# STRAWBERRY HILL CENTER BUFFER REPLANTING

# STRAWBERRY HILL CENTER

## CHARLOTTE-MECKLENBURG PLANNING COMMISSION INTER-OFFICE COMMUNICATION

SUBJECT: Approved Landscape Plan for Petition No. 88-34 by Strawberry Hill Associates, Tax Parcel No. 185-121-29, 17

## FRONT ELEVATION

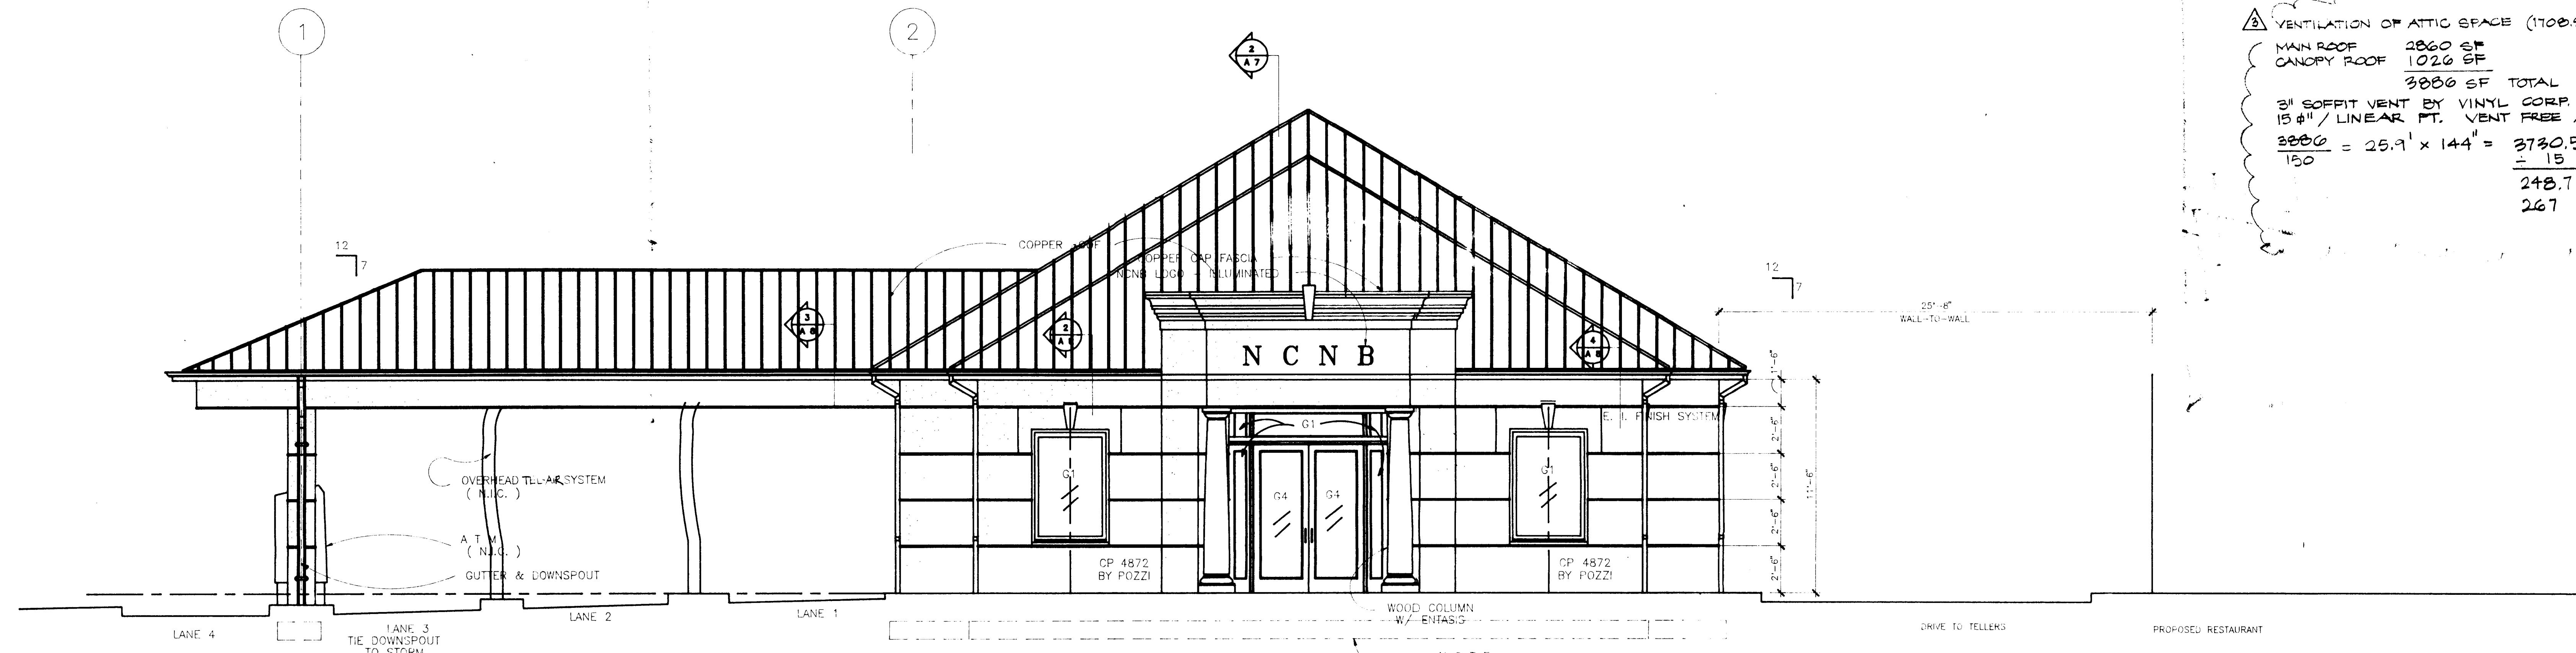
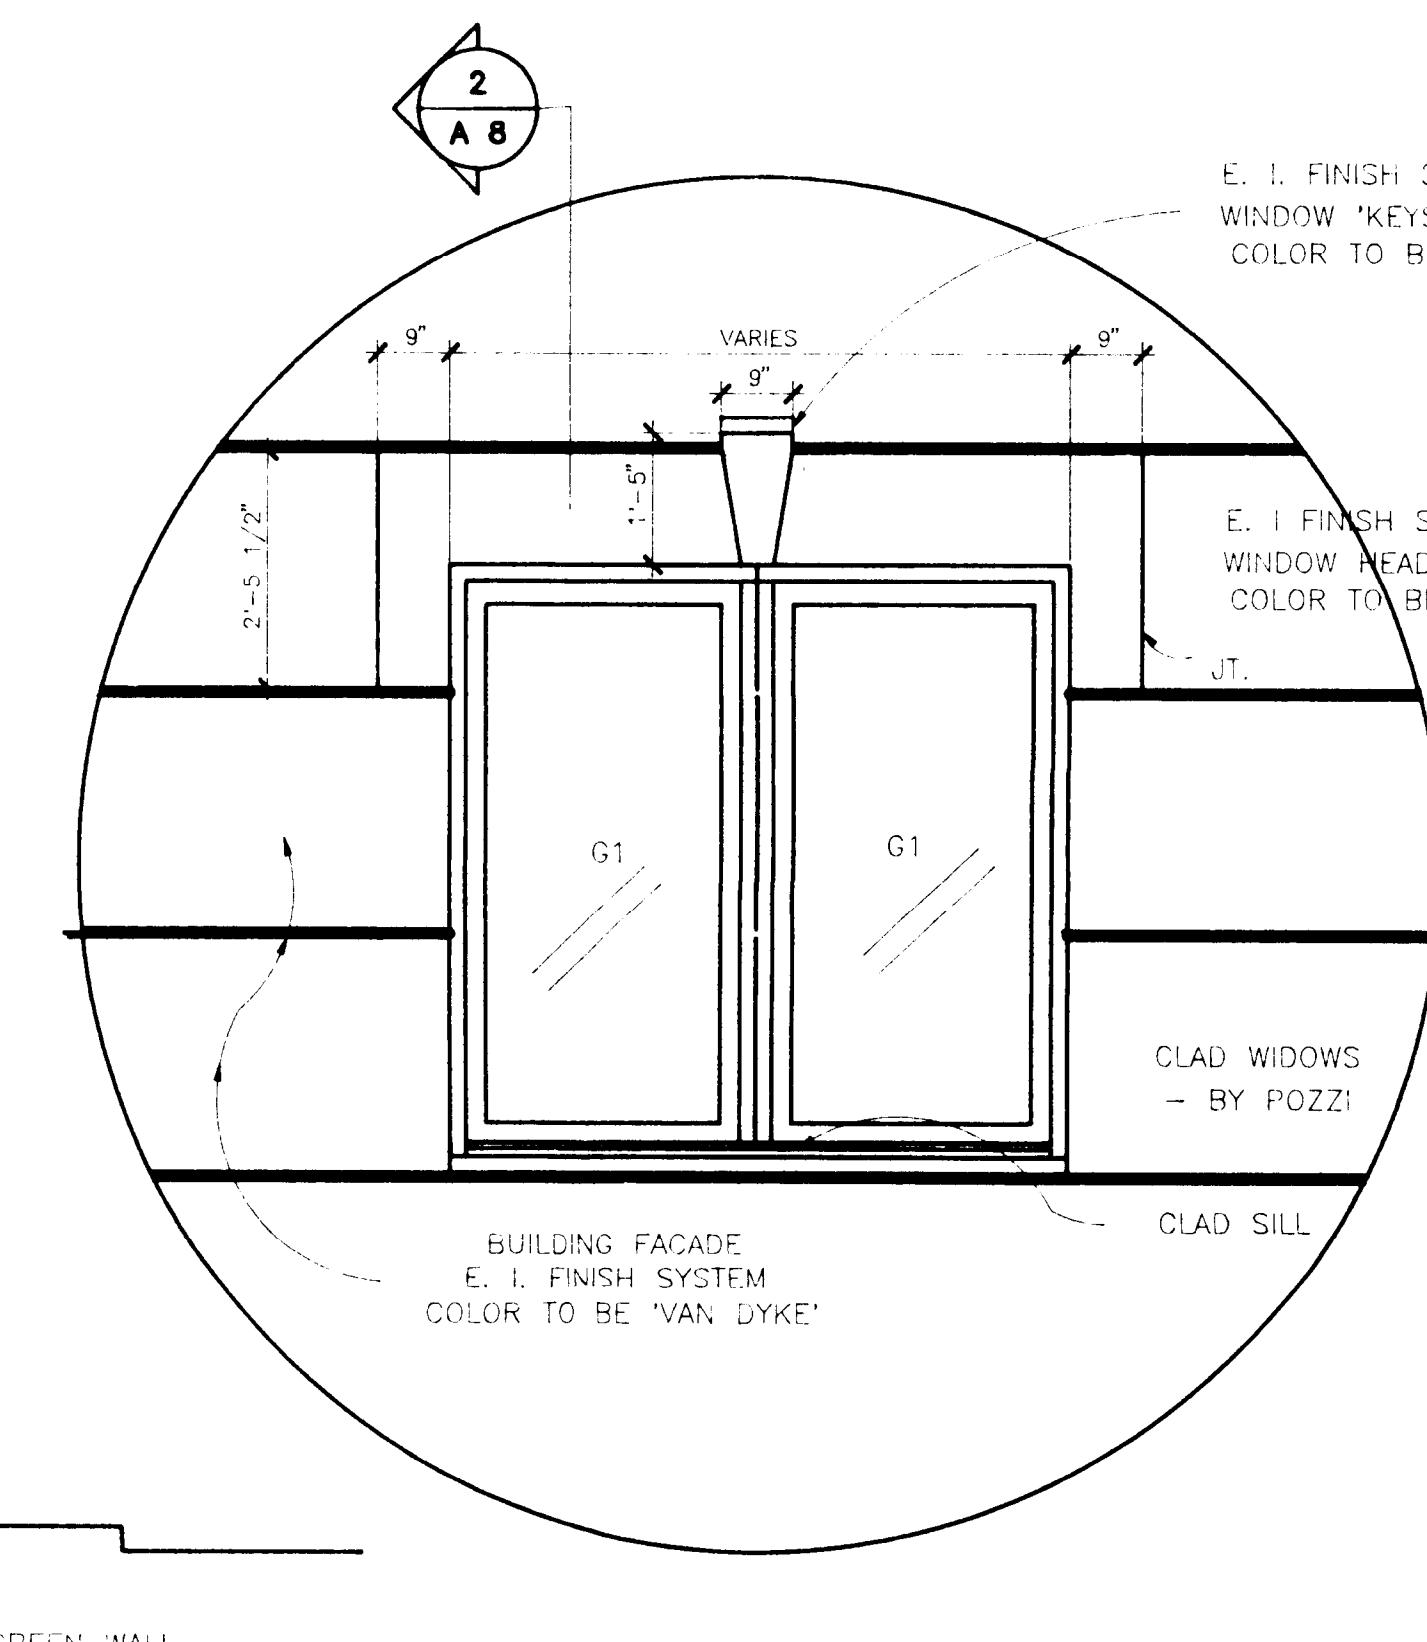
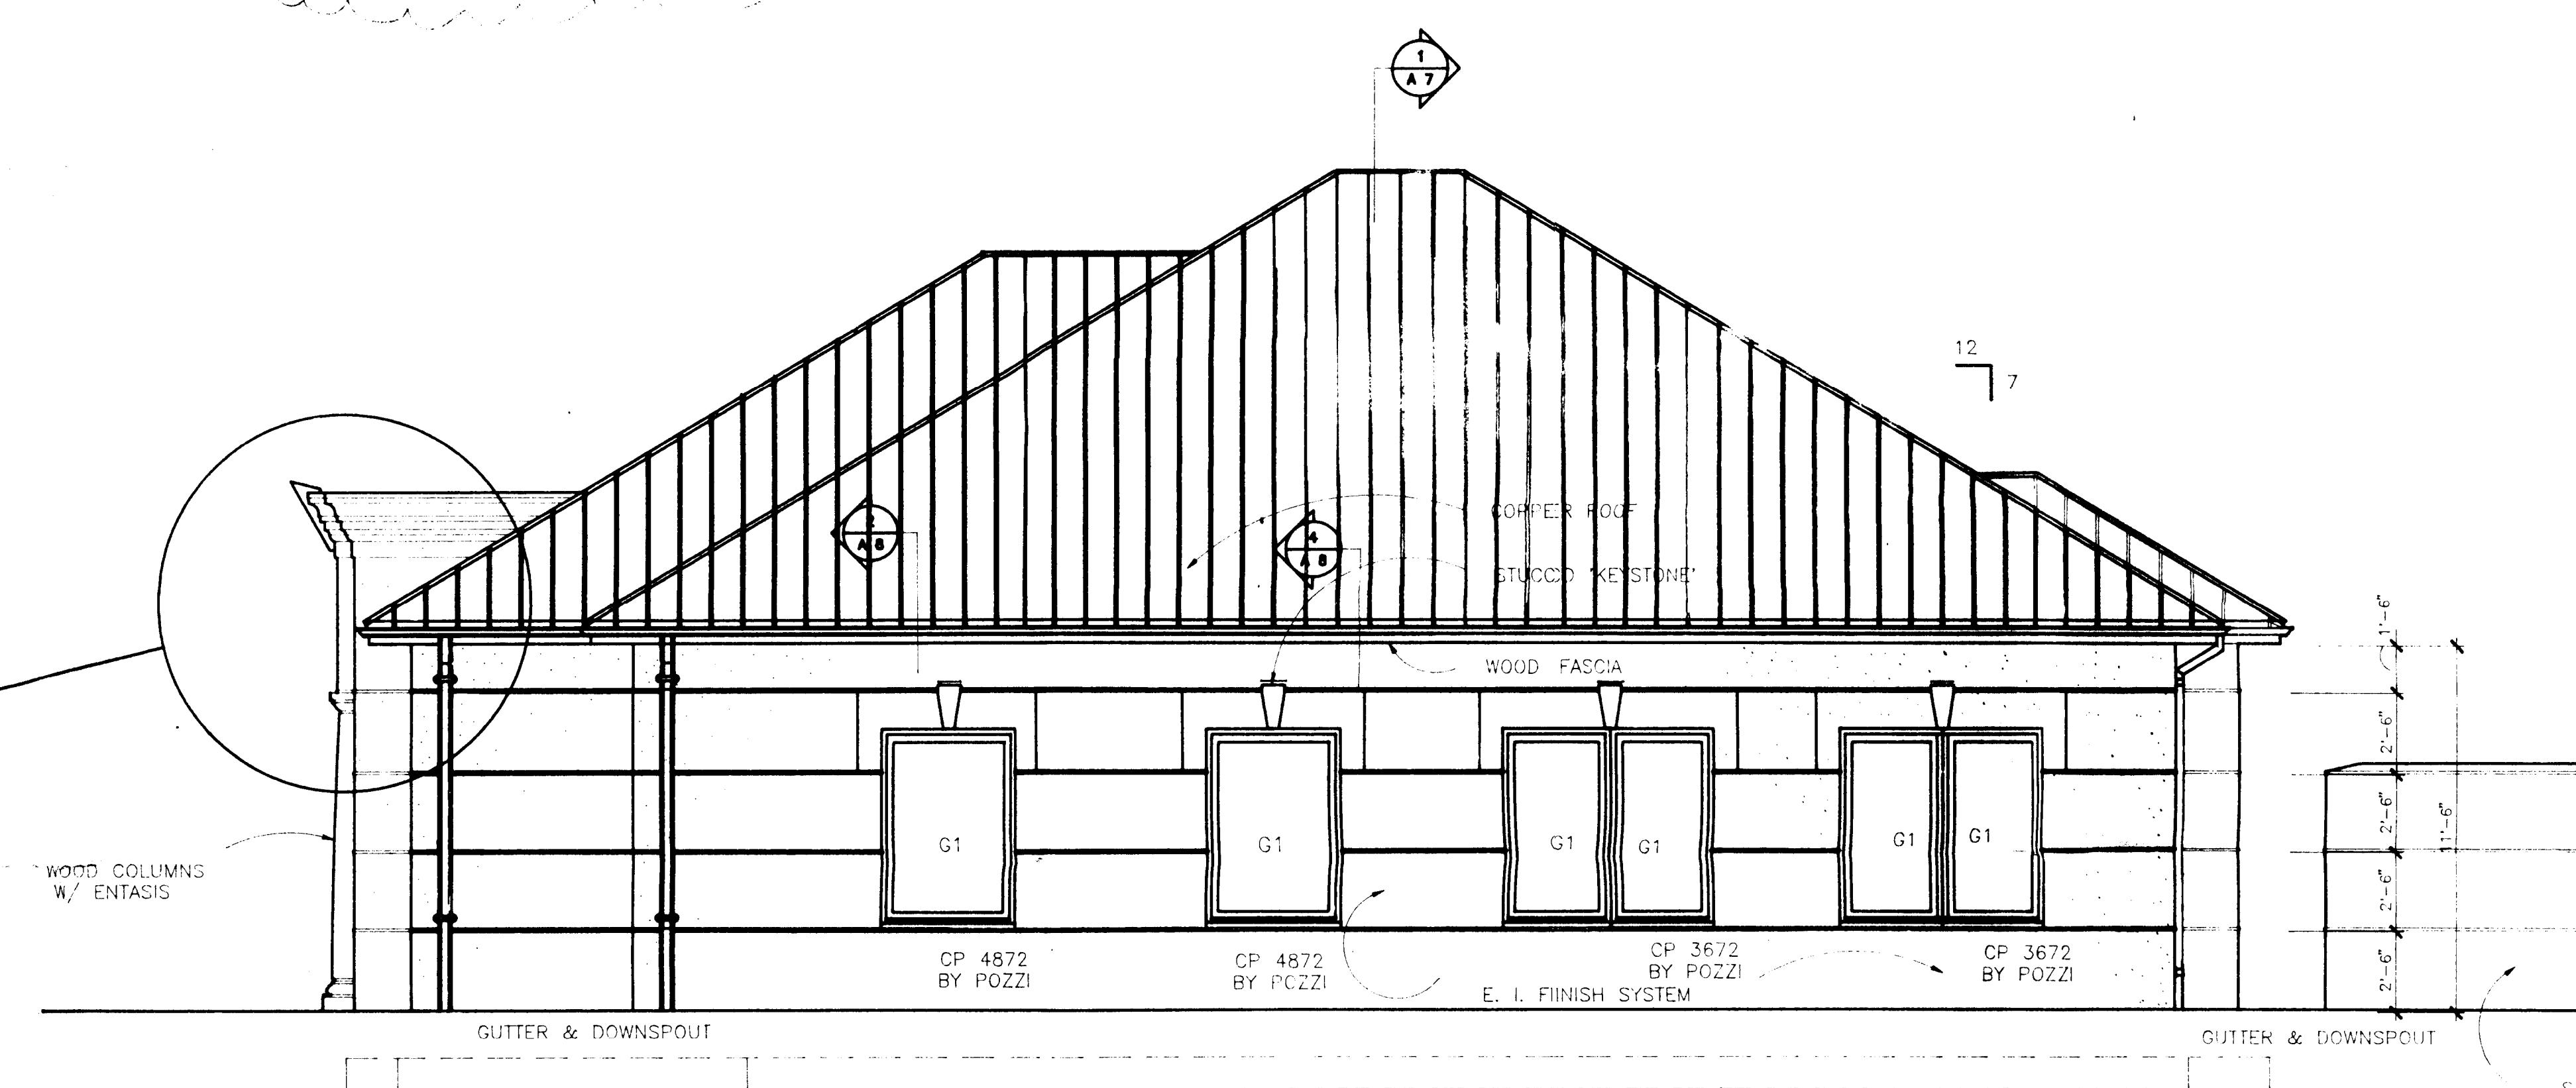
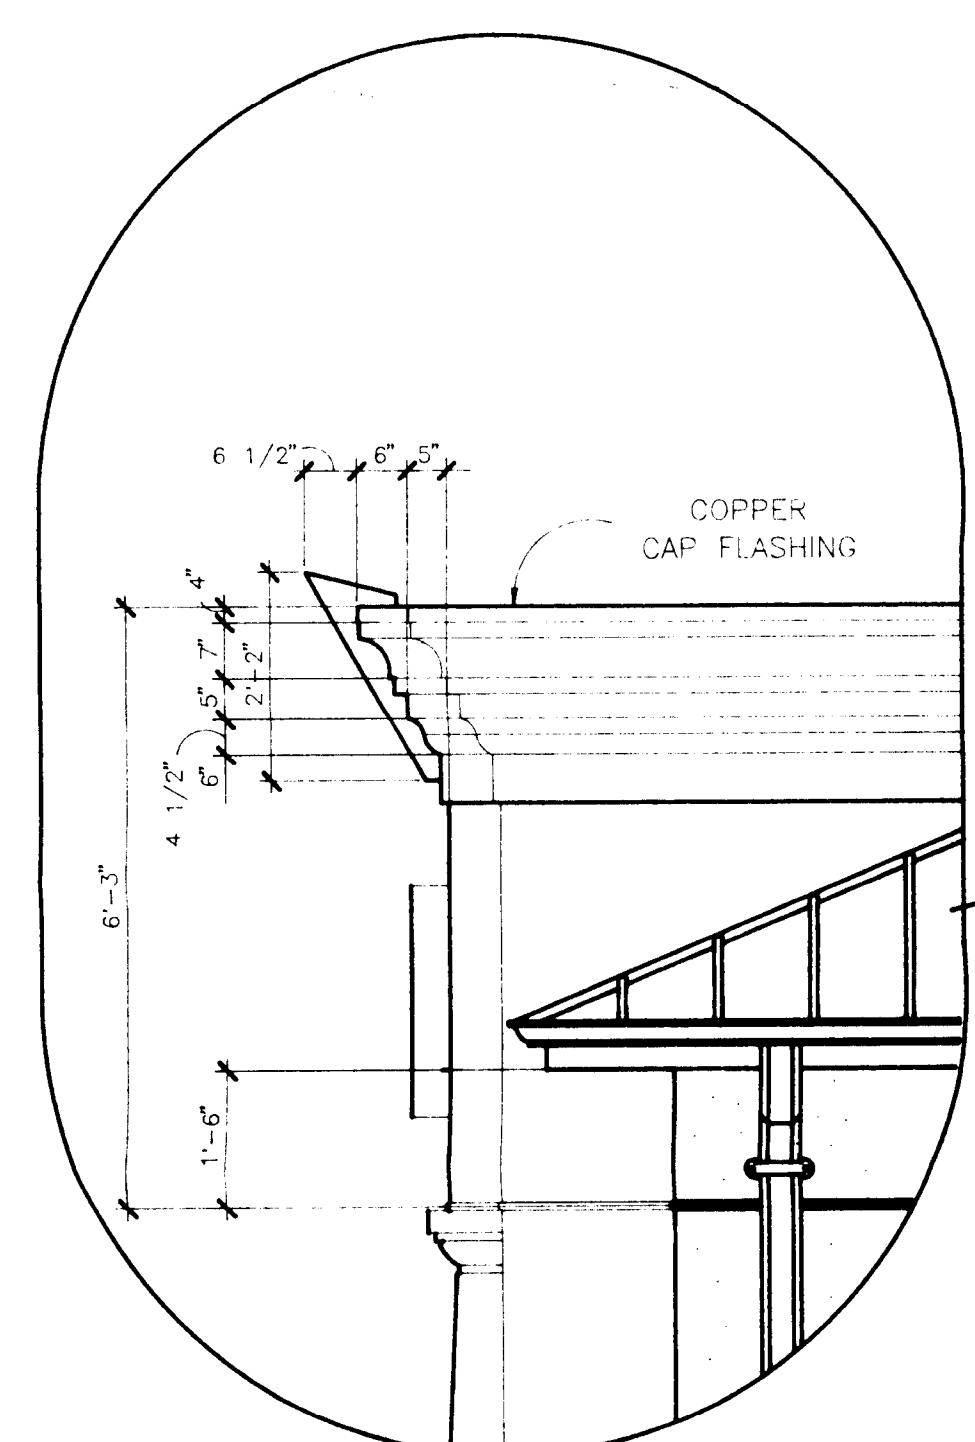
Attached is a revised building elevation for the NCNB bank at the Strawberry Hill Center. The elevation has been revised to add a pitched roof to the bank's elevation. Due to the bank's use of similar materials on the remainder of the building, the building appears to still fit well with the remainder of the center. Since these changes are minor in nature I am administratively approving this plan. Please use this plan when evaluating requests for building permits.

EXTERIOR FINISH COPPER ROOF  
AND WOOD WINDOWS TO COMPLEMENT  
THOSE USED ON STRAWBERRY HILL  
CENTER CHOPS AS REQUESTED IN  
CITY OF CHARLOTTE.
